METROPOLITAN GOVERNMENT OF NASHVILLE AND DAVIDSON COUNTY

STAFF RECOMMENDATION 128 Second Avenue North August 19, 2015

Application: Violation
District: Second Avenue Historic Preservation Zoning Overlay
Council District: 19
Map and Parcel Number: 09306207900
Applicant: Nancy Jones, Possum Legend, LLC
Project Lead: robin.zeigler@nashville.gov

Description of Project: This application is for alterations made that do not match the permit and/or design guidelines. The applicant would like to request approval of the alterations.

Figure 1: Excerpt of plans from preservation permit

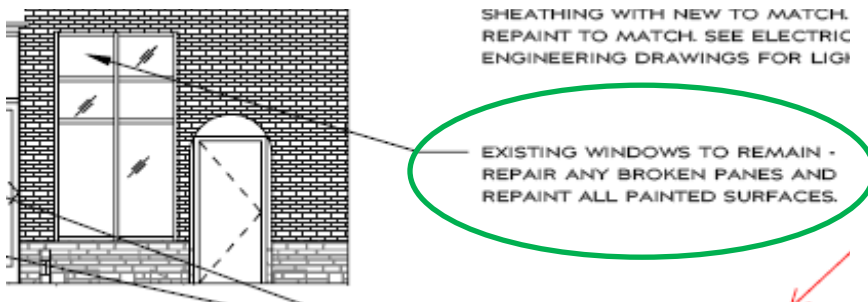
Storefront windows: The drawings submitted in December 2014 for alterations notes that there were no plans to alter the existing storefront windows.

The new storefront incorporates NANA walls with transoms above, which have been approved in the past. (See figure 3.)

The original storefront did not exist; therefore replacement is appropriate. The design guidelines state that replacement windows should mimic the original or be “compatible with the general appearance of the original. In this case, the windows are similar to a configuration approved through MDHA in 1996, with the advice of the MHC. Since a true replication of the original windows would not be conducive to the openness of first-level retail establishments, because the alteration is similar to one approved in 1996, and because the alteration is similar to historic storefronts found in the district, Staff finds the alteration to meet section II.A.3.

Figure 7: Excerpt of plans from preservation permit

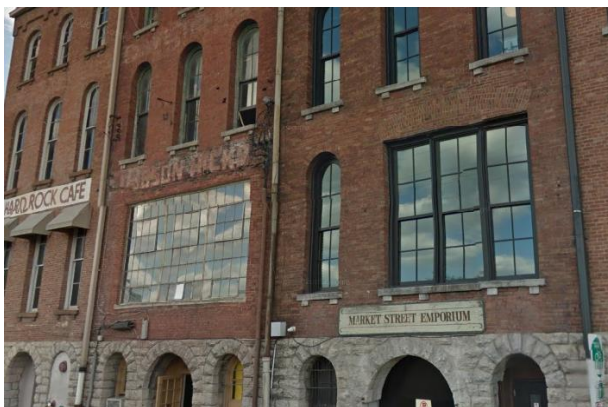
Windows: The First Avenue façade had a roll-up door on the second floor (1st level from Second Avenue). Roll-up doors are not appropriate on principle facades in the historic district; however, since the building already had existing doors, the applicant was advised they could keep them, as shown on the plans they submitted in December.

The applicant has replaced them with new roll-up doors that have changed the dimensions of the previous opening. Roll-up doors do not meet section III. H as they do not replicate the original windows nor are they similar to windows found on this style and period of building. Because the alteration does not meet section III.H of the design guidelines. Staff recommends disapproval of this alteration and that the roll-up doors be replaced with windows that meet the design guidelines. One option is to reestablish the punched, arched, window openings that were there originally. A second option would be to reestablish the previous opening, as it lined up with the windows above, and replace the roll up doors with windows that meet the design of industrial windows seen on multiple buildings on the First Avenue side and seen originally on the historic Second Avenue façade of this building. This is the same treatment that was recommended in 1996 when a previous owner proposed to change the windows.

Figures 10: Wall sign added without a permit.

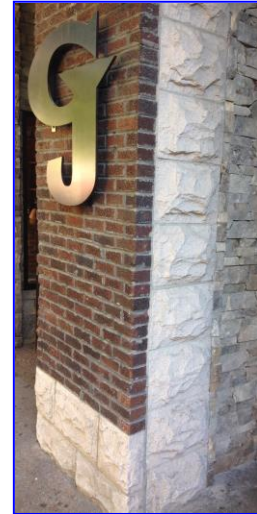
Signage: A small wall sign (48 sq ft) and banner sign (dimension unknown) were added to the front façade. (See figures 3 and 10). The Second Avenue side of the building is allotted ninety-nine and one-half square feet (99.5 sq ft) since there is a projecting sign. The existing marquee sign, originally approved under different design guidelines in 1997, includes two signs that together are approximately 120 square feet. The existing signage on the Second Avenue side exceeds the sign allotment of the current design guidelines; therefore staff recommends disapproval of the addition of the wall and banner signs.
